# CLOVERLEAF FILING 2

# STORM SEWER AND POND PLANS

AS-BUILTS  
05/24/2023  
SF-21-023

# V1\_As-Built Construction Drawing.pdf Markup Summary

AS-BUILTS  
05/24/2023  
SF-21-023

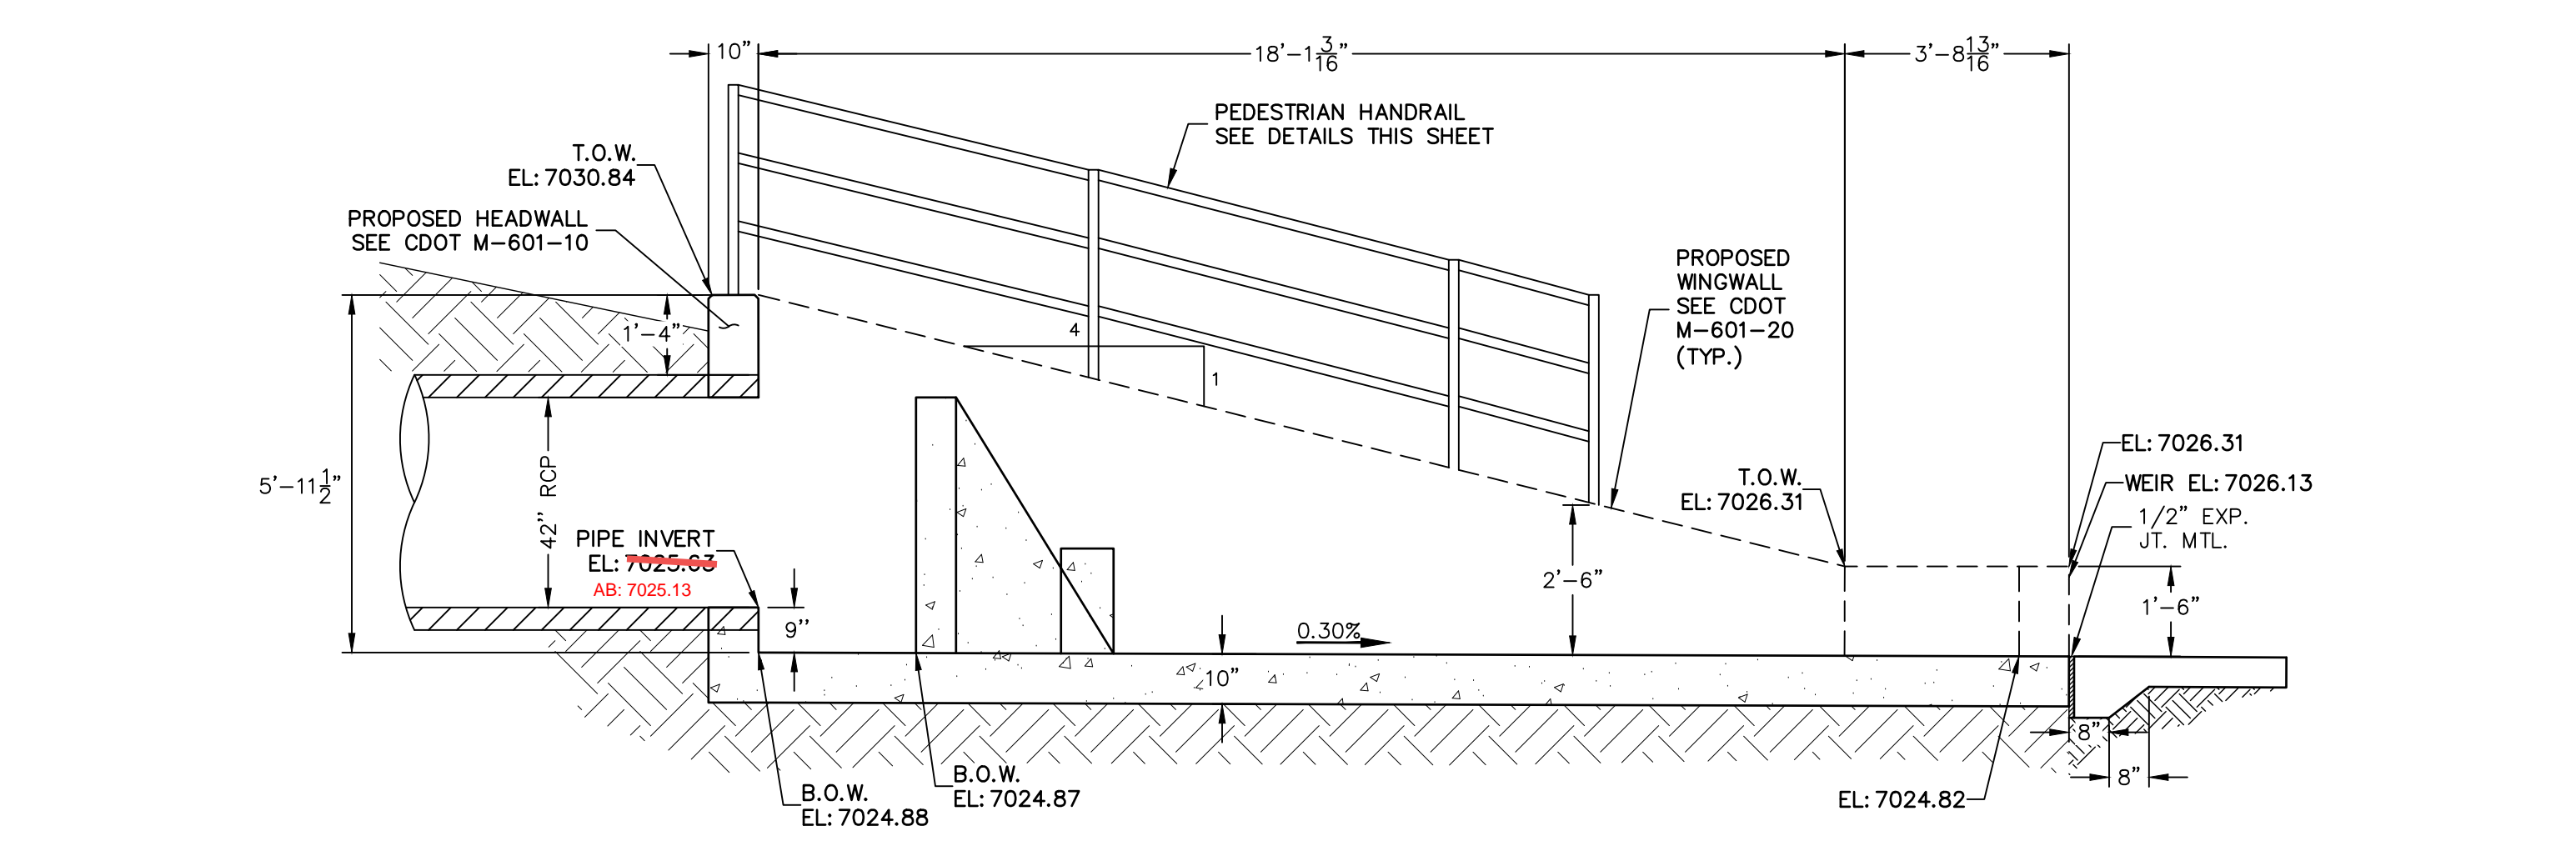
Need MHFD outlet structure calc to verify acceptability of the changes shown on this sheet

**POND 3 OUTLET STRUCTURE NOTES:**

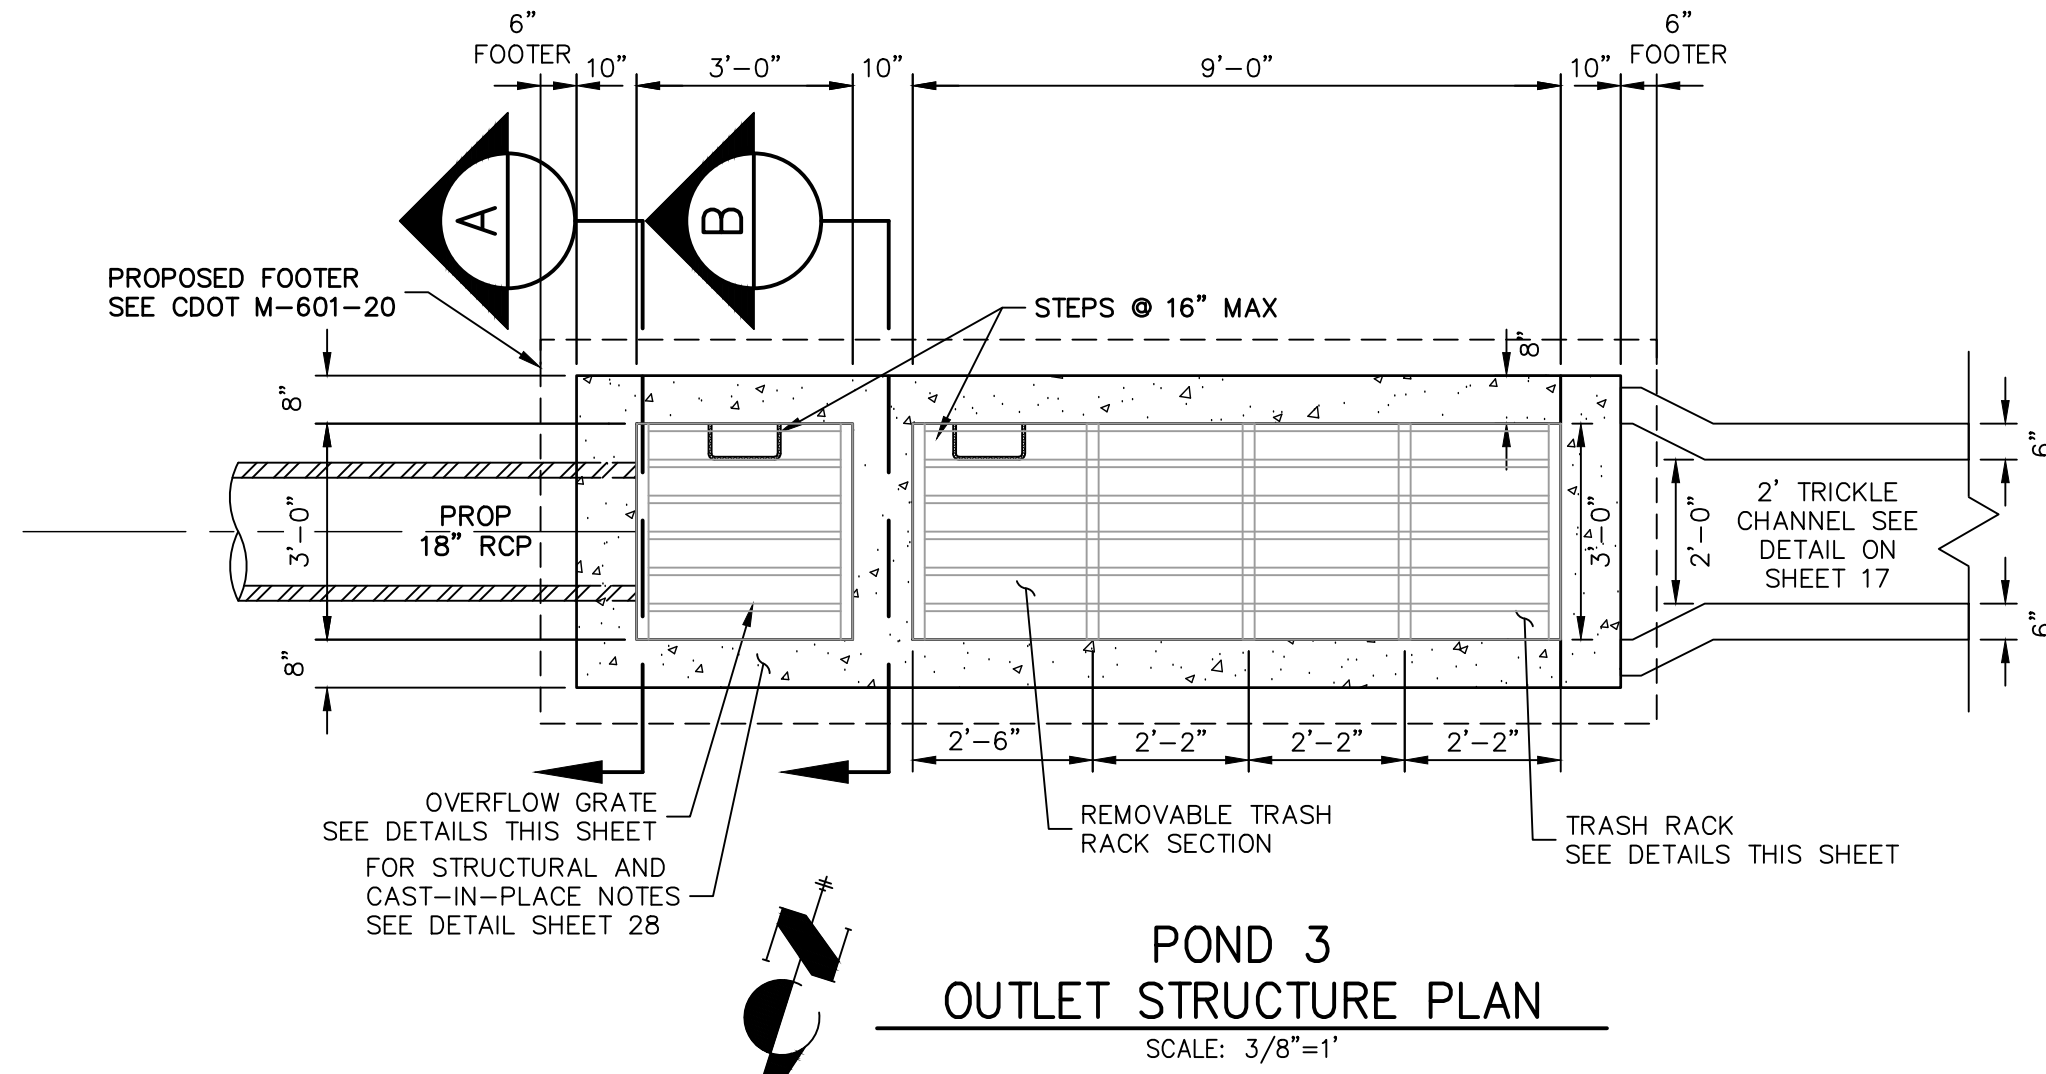
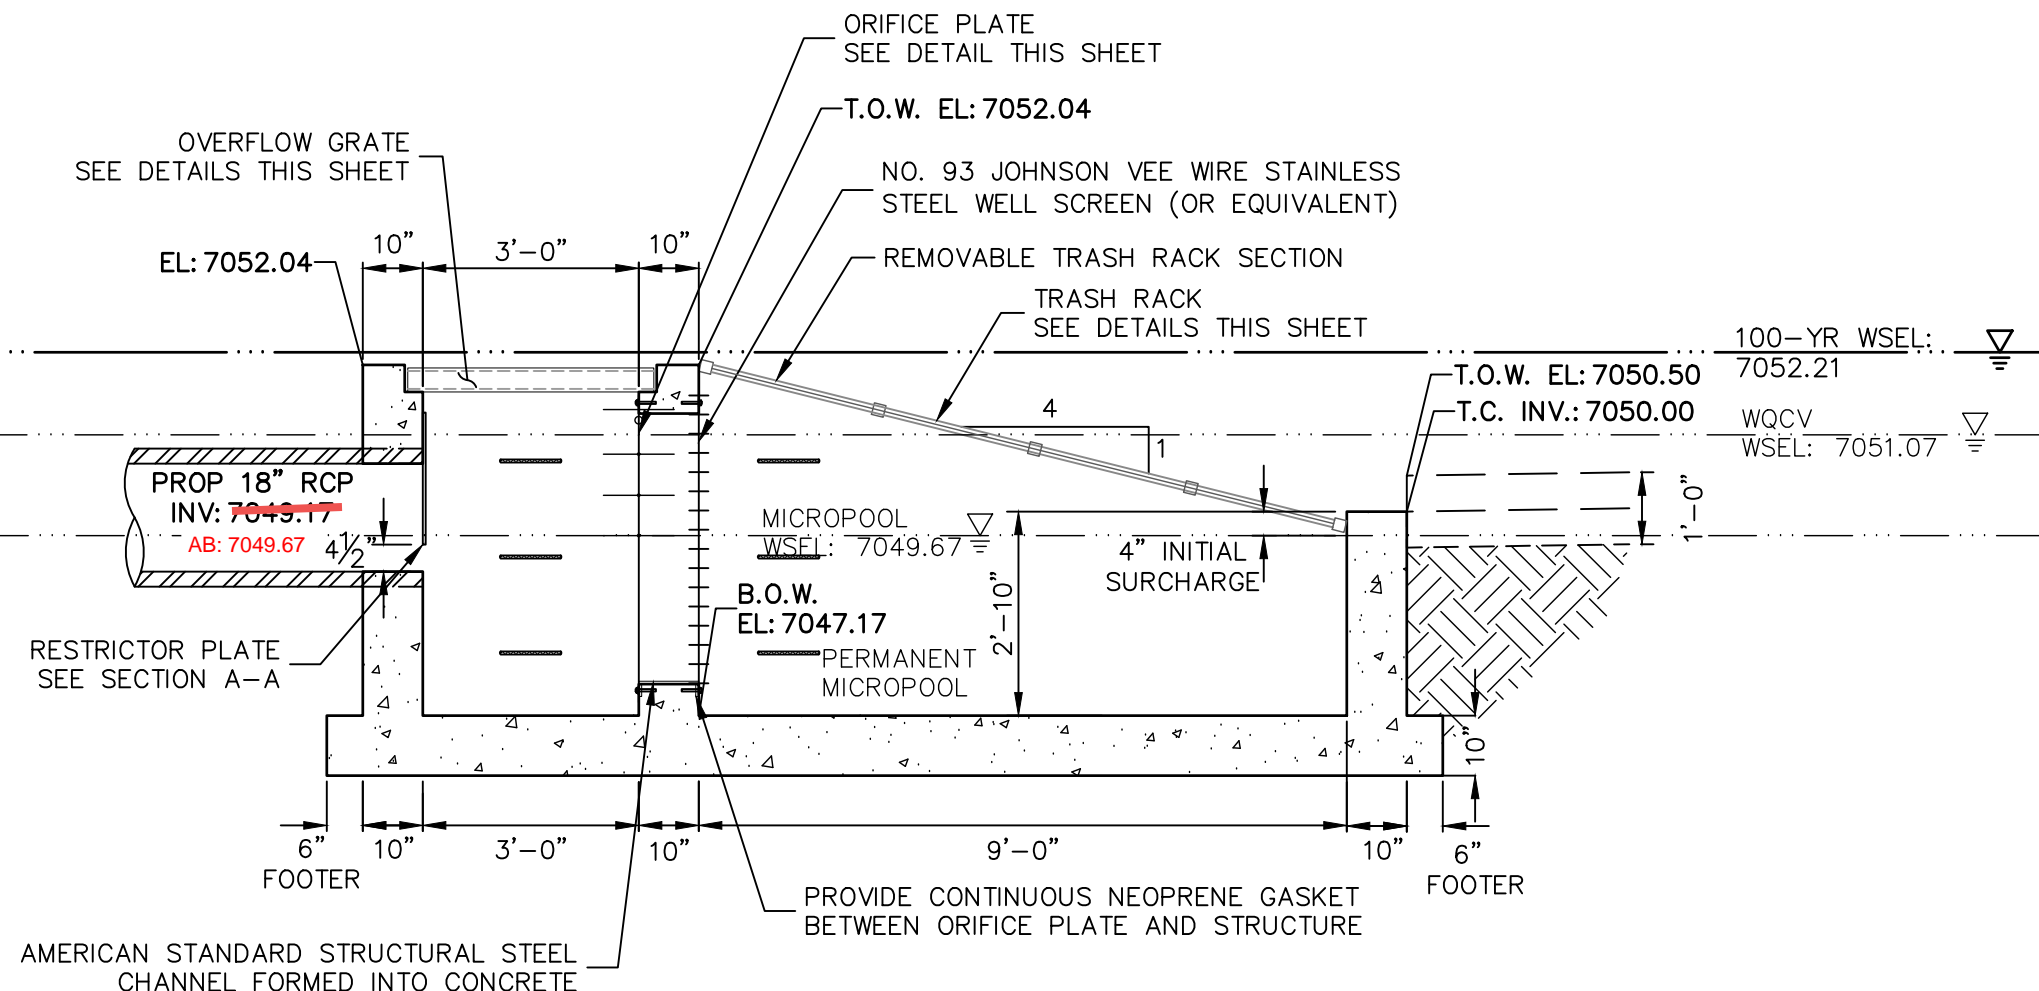
Need MHFD outlet structure calc to verify acceptability of the changes shown on this sheet
